Office Action Summary

10/628,588

DETAILED ACTION

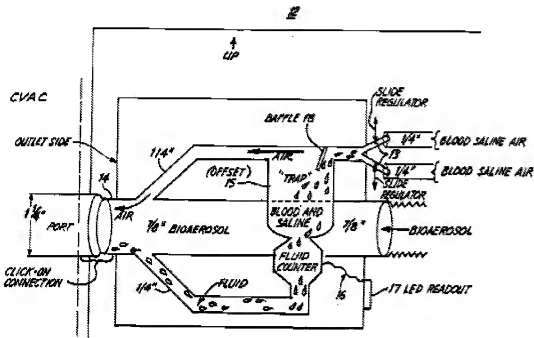
Claim 43 recites an air pathway from the inlet to the separation chamber and a fluid pathway from the inlet to the separation chamber, the fluid pathway being separate from the air pathway. The instant invention only discloses a single pathway from any of the individual inlets (13) to the separation chamber (15)(see applicant's figure 2, *infra*).

Fig. 1

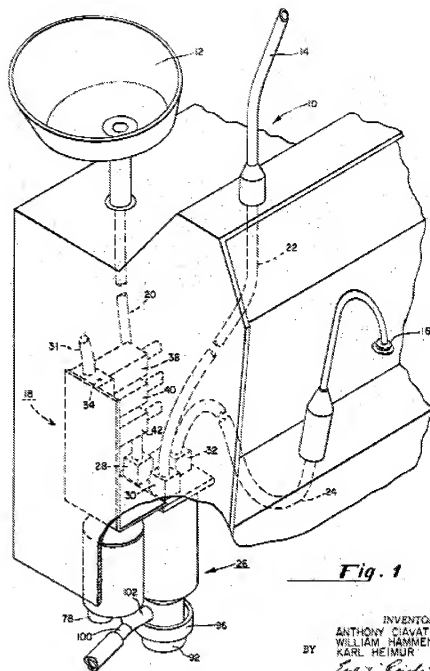
a connector (54, 68) comprising an inlet, an outlet in communication with the vacuum source (28, 30, 32), a separation chamber (68) in communication with the inlet, an air pathway (72, 73, 74, 70, 78) in communication with the separation chamber (68) and the outlet, and a fluid pathway (100) separate from the air pathway (72, 73, 74, 70, 78) and in communication with the separation chamber (68);

a removable decontamination unit (70) capable of being coupled to the connector (54, 68)(col. 2, line 69-col. 3, line 25)(see figures 1, annotated figure 2, and figure 5, *infra*).

FIG. 2

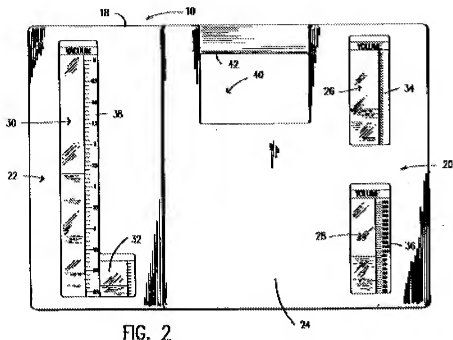
Regarding claim 38, Goosen teaches a flow volumetric flow indicator (26)(figure 2, *infra*).

At the time of the invention, it would have been obvious to one of ordinary skill in the art to add the flow indicator of Goosen to the evacuation apparatus of Ciavattoni in order to provide a means of monitoring the flow rate of the system.

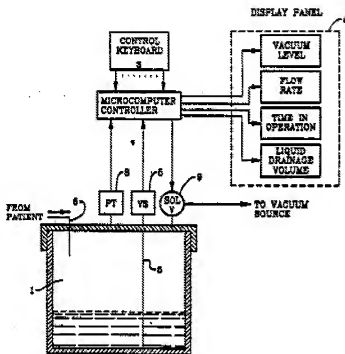
Walker teaches a keyboard (3) for controlling a medical suction apparatus (see figure 1, *infra*).

At the time of the invention, it would have been obvious for one of ordinary skill in the art to add the keyboard of Walker to the evacuation apparatus of Ciavattoni in view of Goosen in order to provide a means of controlling the air pressure and vacuum applied to a patient. See *Ex Parte Smith*, *supra*.
